# TN06007

V51RX2 migration

Rev. 02 — 5 March 2009

Technical note

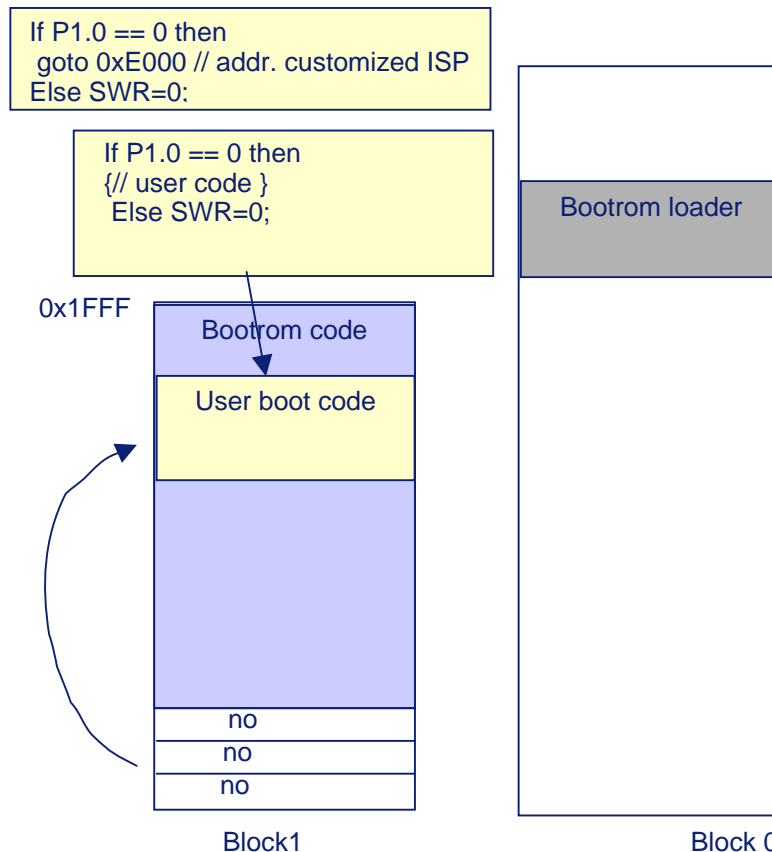
The 89V51RX2 does enter the ISP mode when auto baud character has been detected within 400 msec @12Mhz after reset

Forced entering ISP mode with PSEnN is not possible in those applications where this feature has been used. The 89V51RX2 will enter parallel mode in that case. Use the auto baud character detection instead. The programming program Flash Magic is using this method and is asking for (only) a reset before programming.
